DRB Application No.: 10DRB- 70015 Project # 1008059
Project Name: North Albuquerque Acres Unit B
Agent: Slagle Herr Architects Phone No.: _____

Project Name: *North Albuquerque Acres Unit B*

RE: PROPOSED DEVELOPMENT AT 5454 VENICE NE, BETWEEN SAN MATEO NE AND I-25
FREEWAY, ALBUQUERQUE, NM

**FILE: PROJECT #1008059
09EPC-40061 SITE DEVELOPMENT PLAN FOR BUILDING PERMIT**

date
1/8/10
sheet
A201

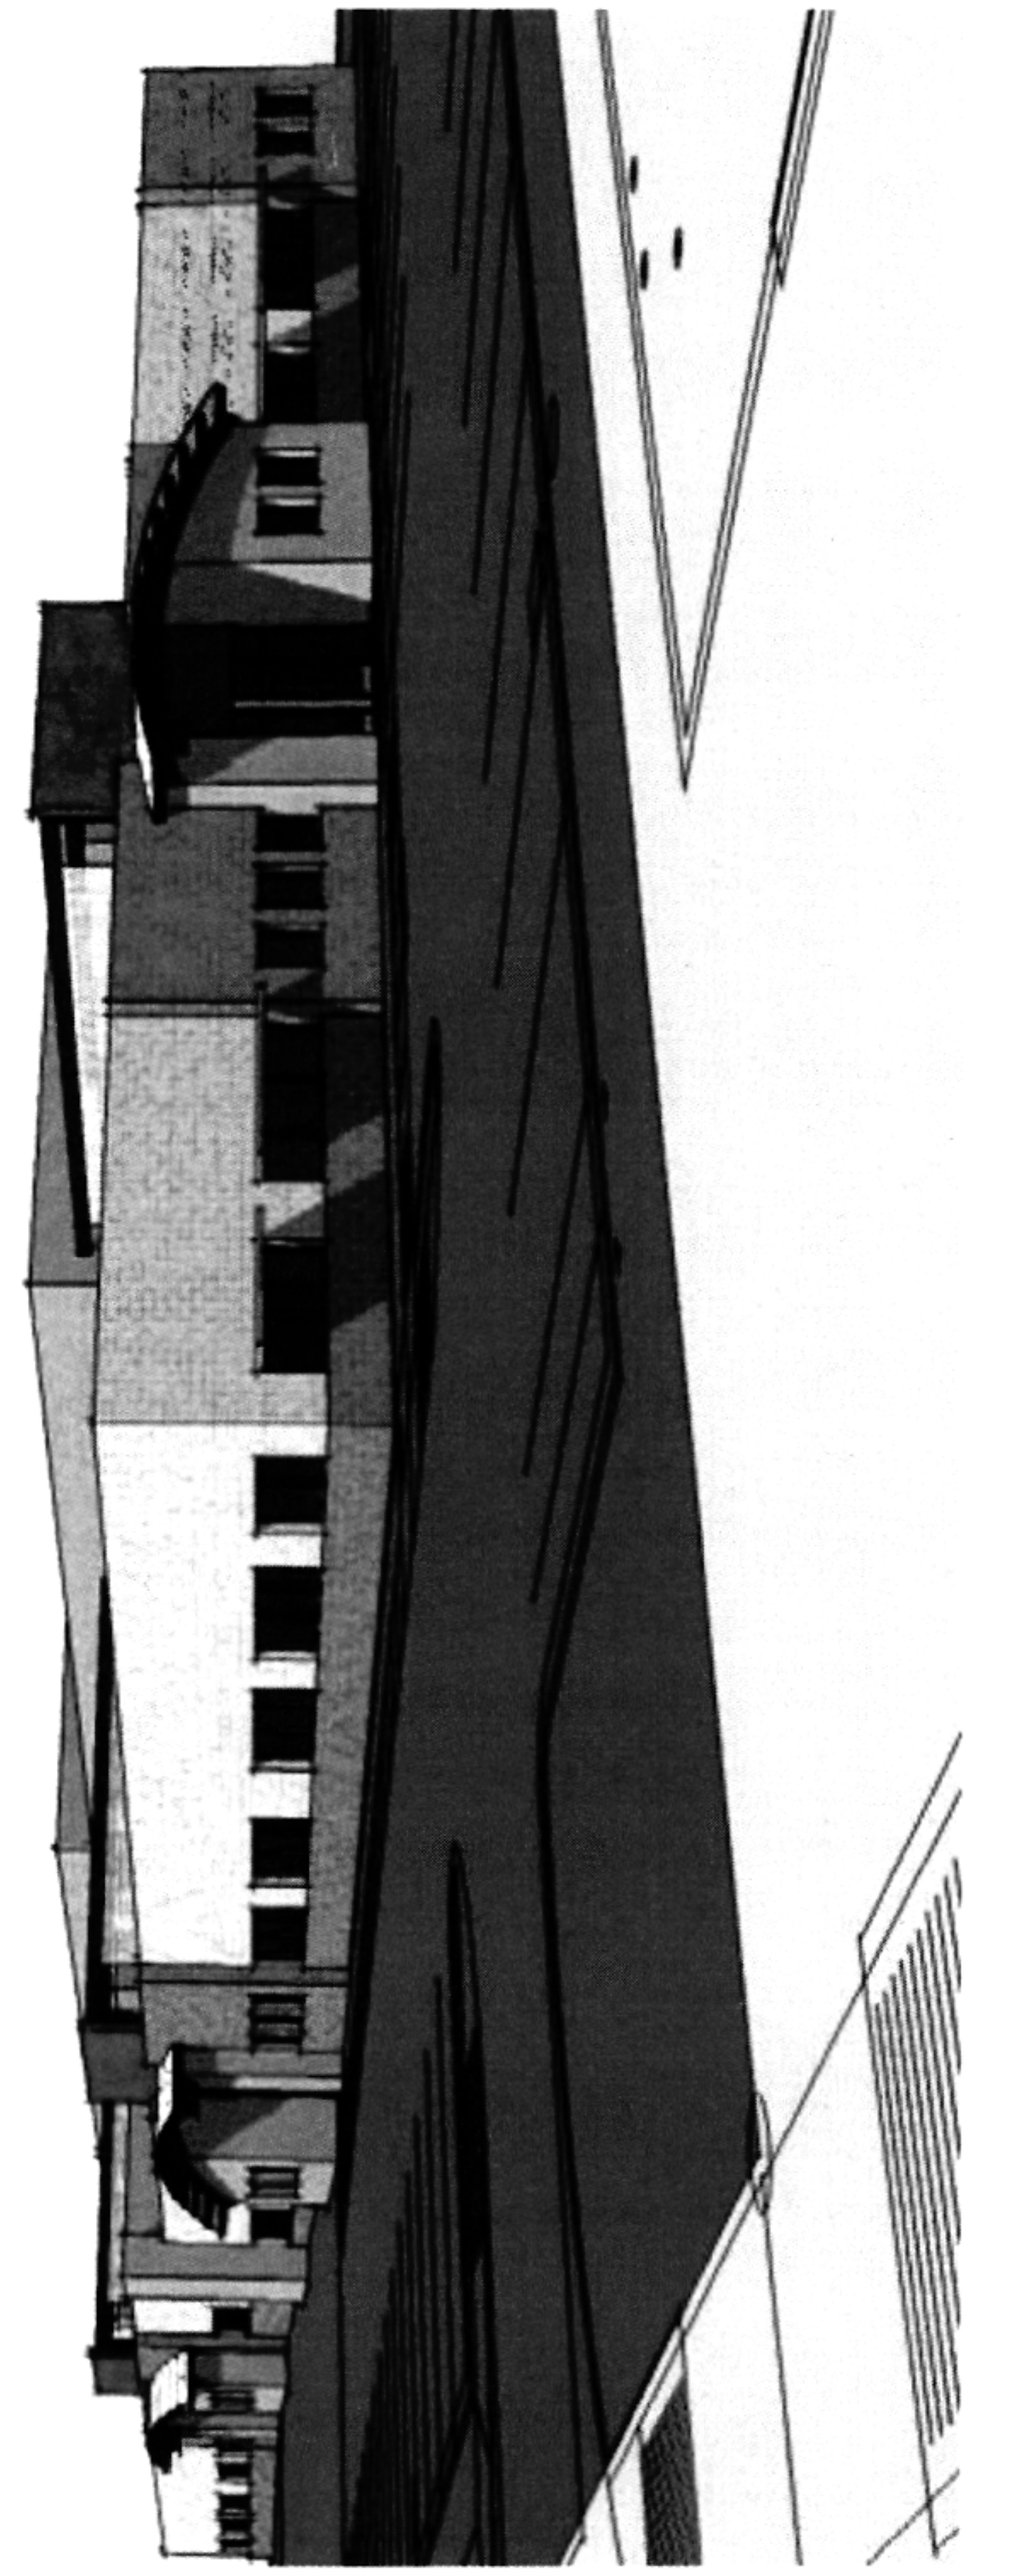
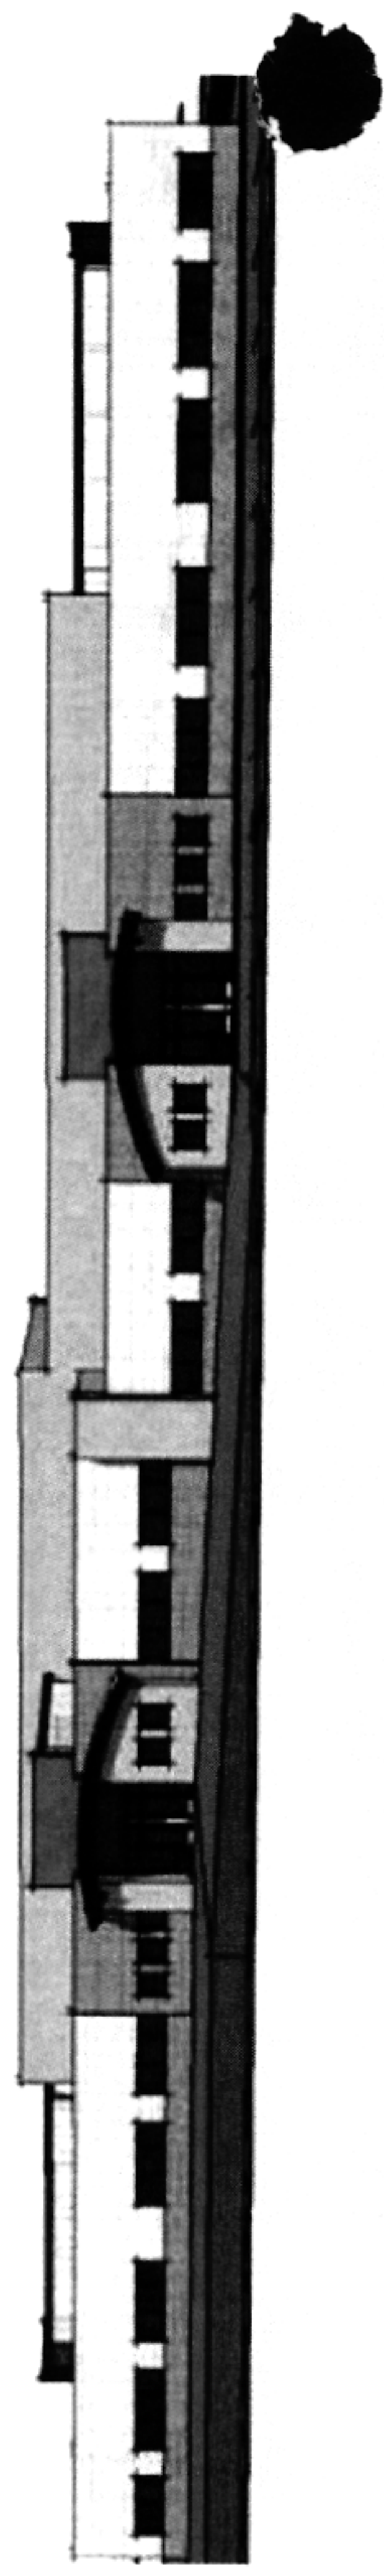
2. Prior to application submittal to the DRB, the applicant shall meet with the staff planner to ensure that all conditions of approval are met.
3. The specific color of the 8' CMU wall shall be identified on Sheet A002.

Condition 3: The color of the 8' CMU wall has been added to Sheet A002.
